**CITY OF MOUNDSVILLE
MARSHALL COUNTY, WEST VIRGINIA
PROPOSED
PHASE II SHOWER ROOM IMPROVEMENTS
FOUR SEASONS SWIMMING POOL BUILDING**

**ADDENDUM #1
November 19, 2020**

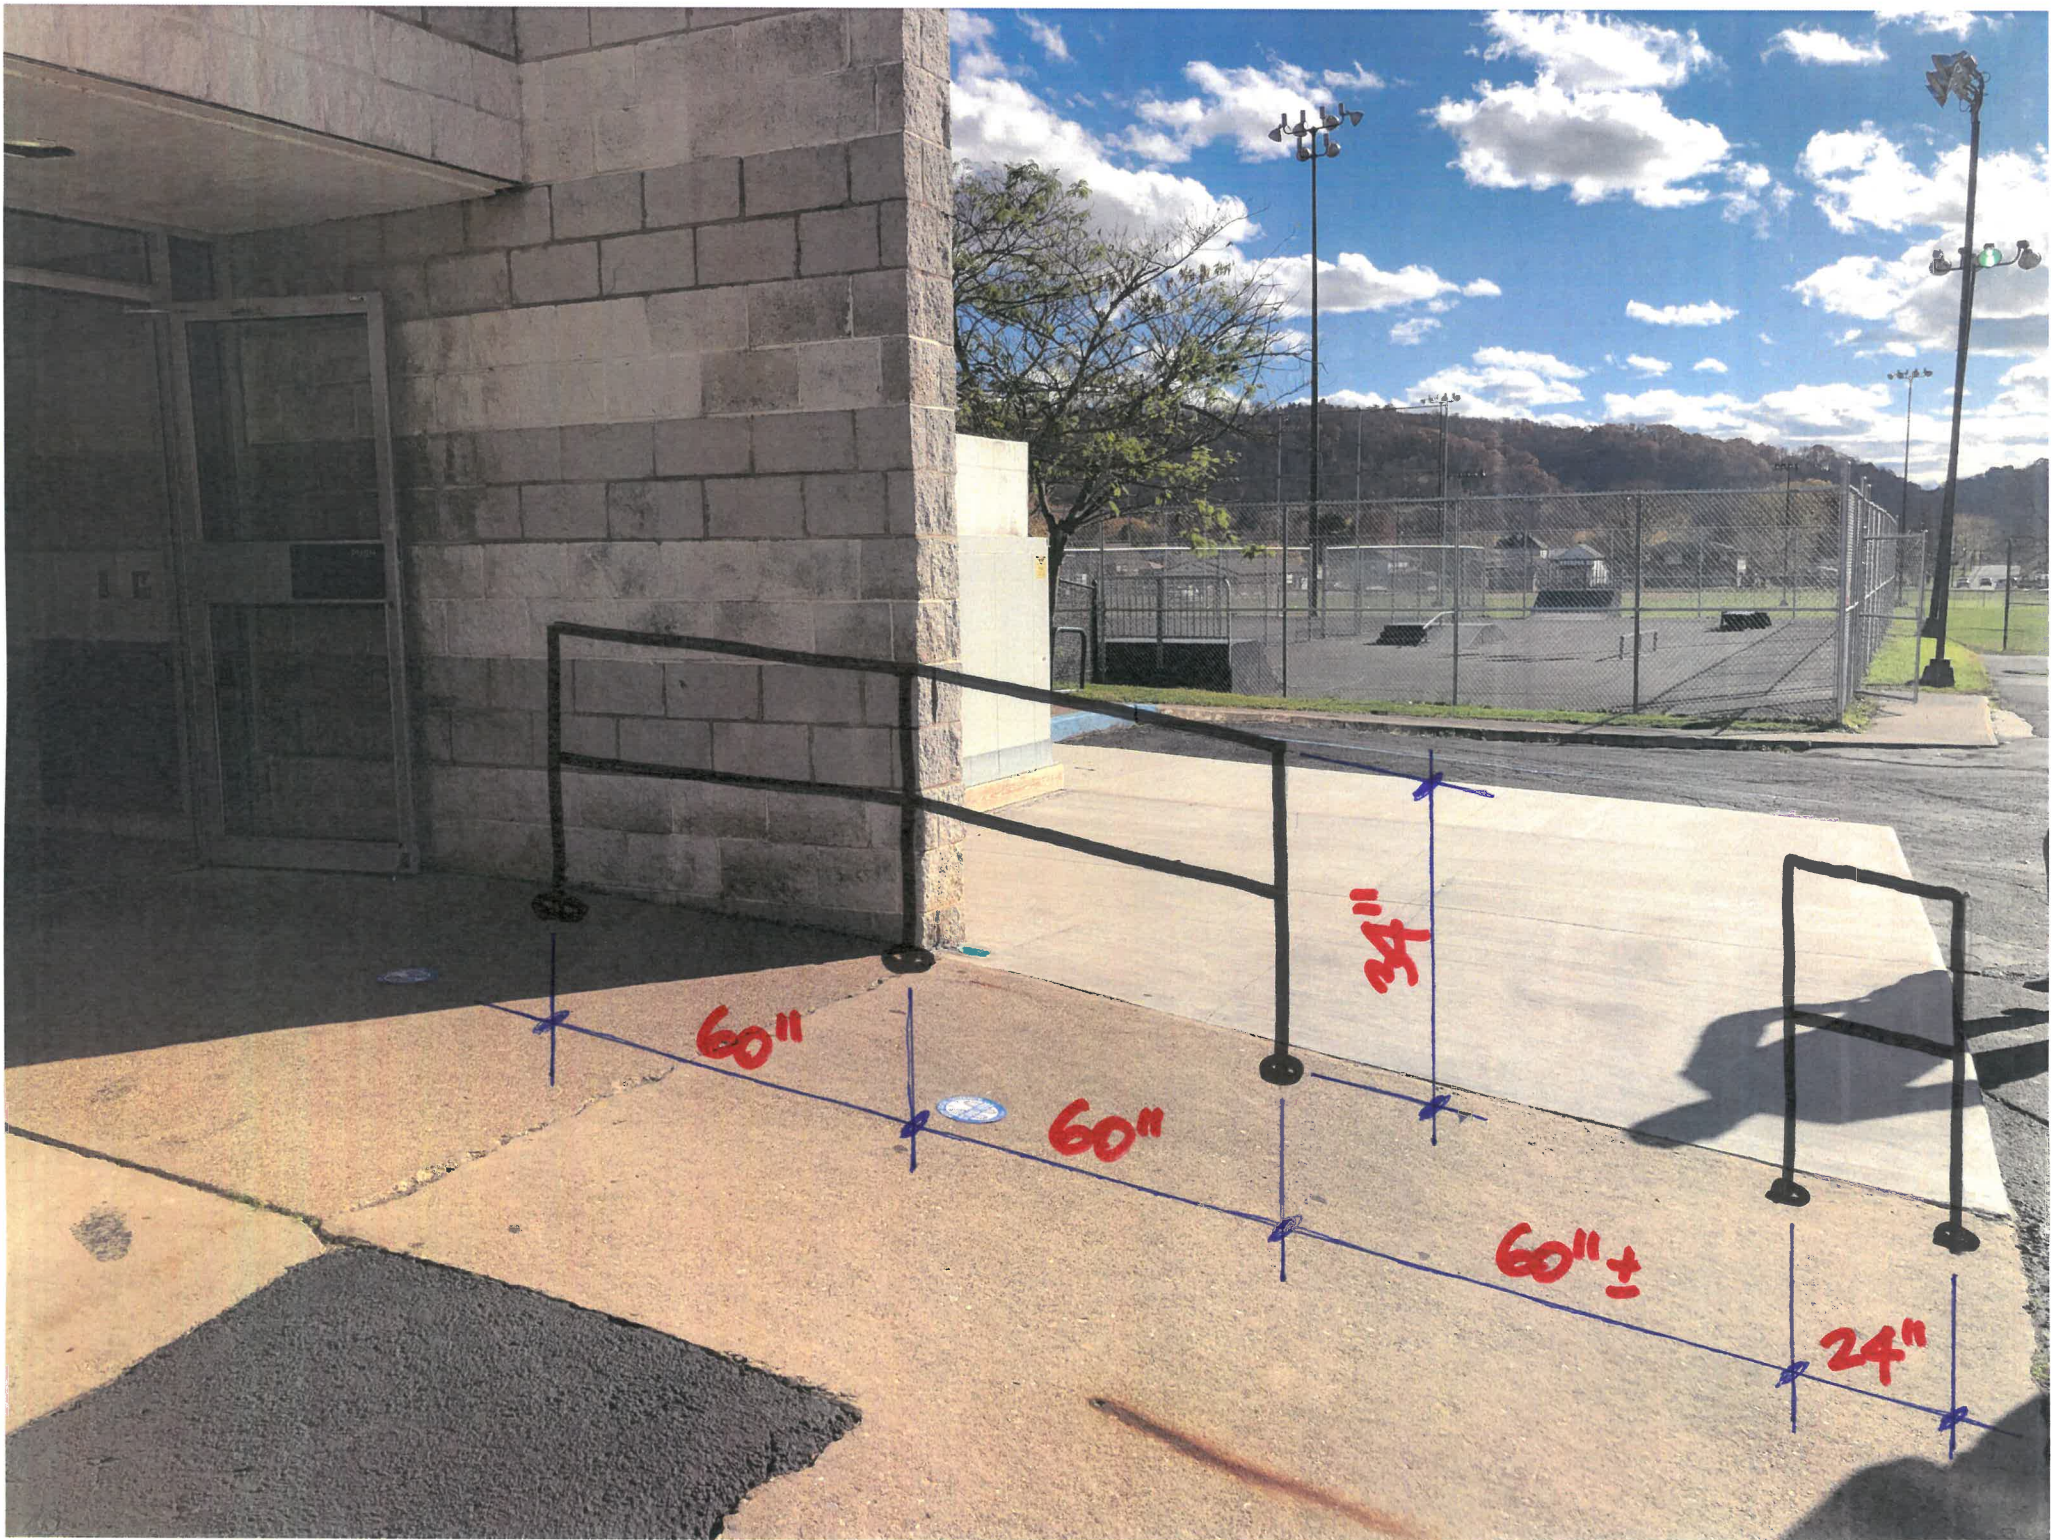
-Sheet A1.00 -REVISE arrangement of painted galvanized handrails as shown on the photo/sketch attached to this Addendum. Contractors Option: Handrails may be surface mounted with 4 bolt base coupler that accommodates slope.
